Project No. 2146

ADDENDUM NO. 1 TO THE CONTRACT DOCUMENTS

2146 – OKA PARK ADDITIONS, PHASE 3

BROKEN BOW, OKLAHOMA
OKA PARK ADDITIONS
PHASE 3
BID SET
ADDENDUM NO. 1
DEMO PLAN

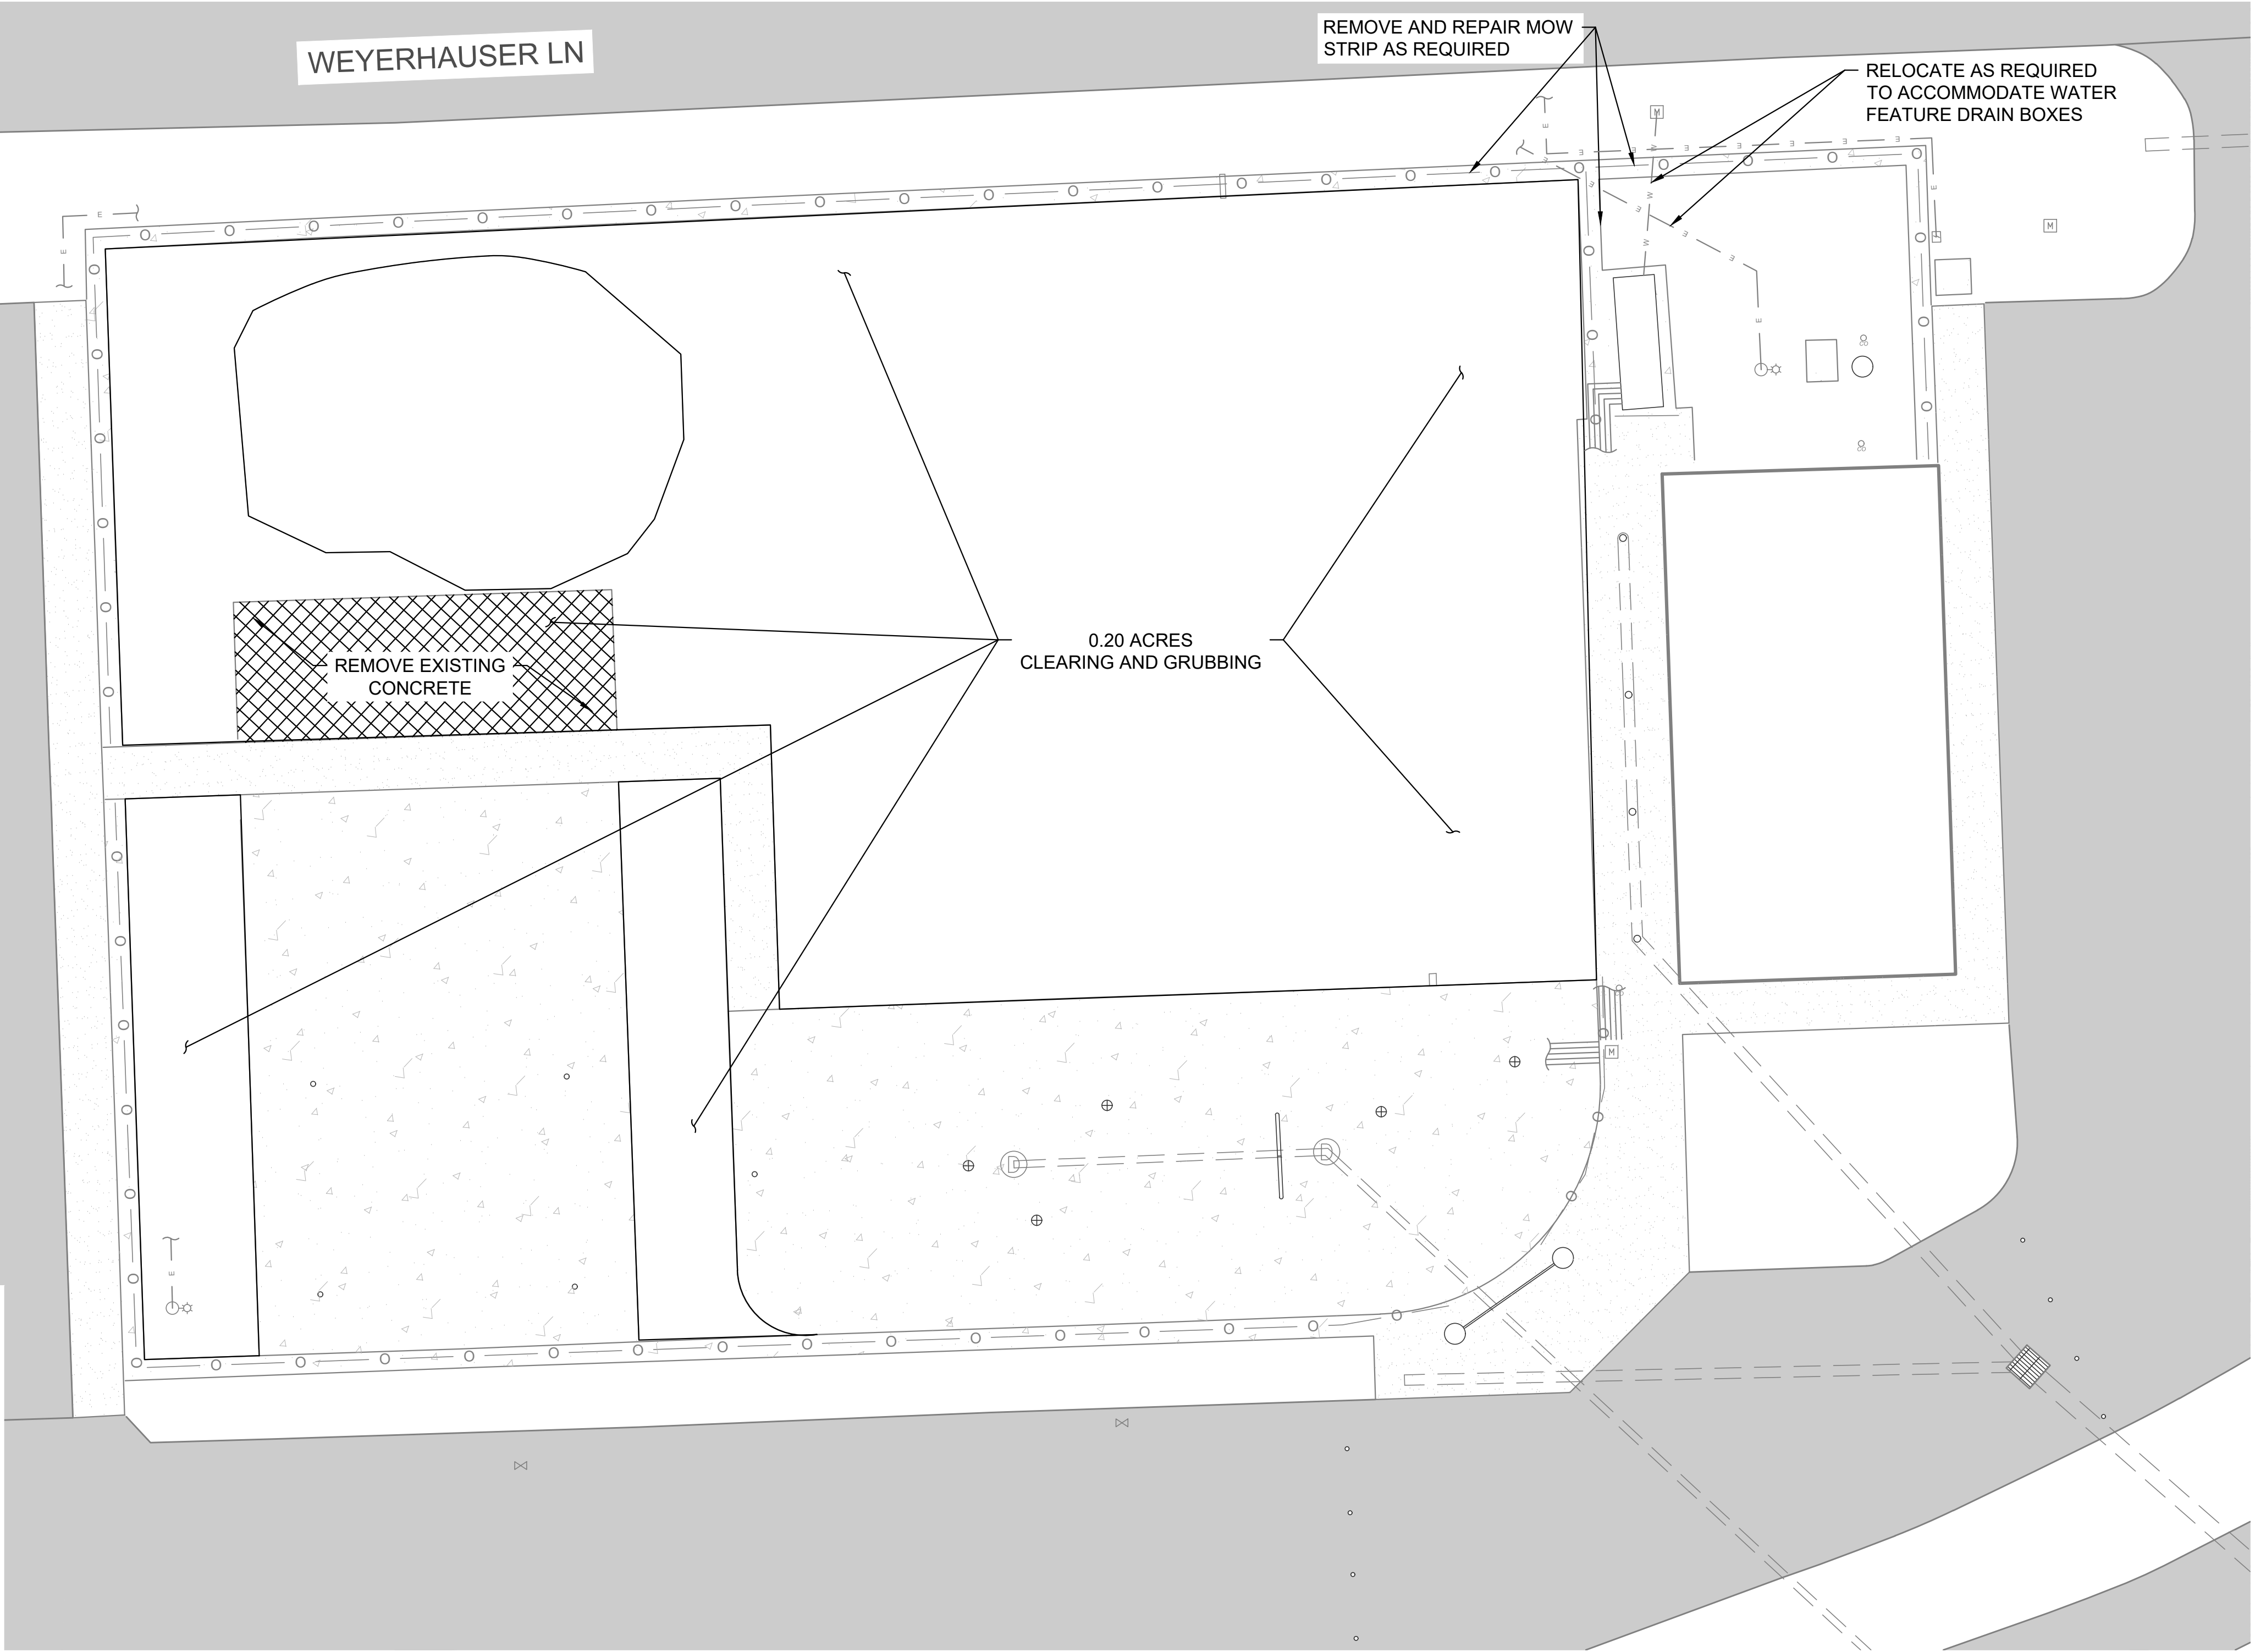
- a.** Revise Notes No. 4, Plan Sheet No. 2, “If necessary, all adjustments to existing utilities, including electrical, water service, and water feature lines shall be considered subsidiary to the splash pad, completed lump sum bid item.”
- b.** Delete and Replace Plan Sheet No. 4 with Plan Sheet No. 4 Addendum No. 1
- c.** Delete and Replace Plan Sheet No. 10 with Plan Sheet No. 10 Addendum No. 1
- d.** Delete and Replace Plan Sheet No. 11 with Plan Sheet No. 11 Addendum No. 1
- e.** Revise Plan Sheet No. 12, Detail E, Concrete Cap, all locations, ~~6-x-6~~ 4 x 4, W1.4 x W1.4 WWF as identified in the plan and sections of the detail
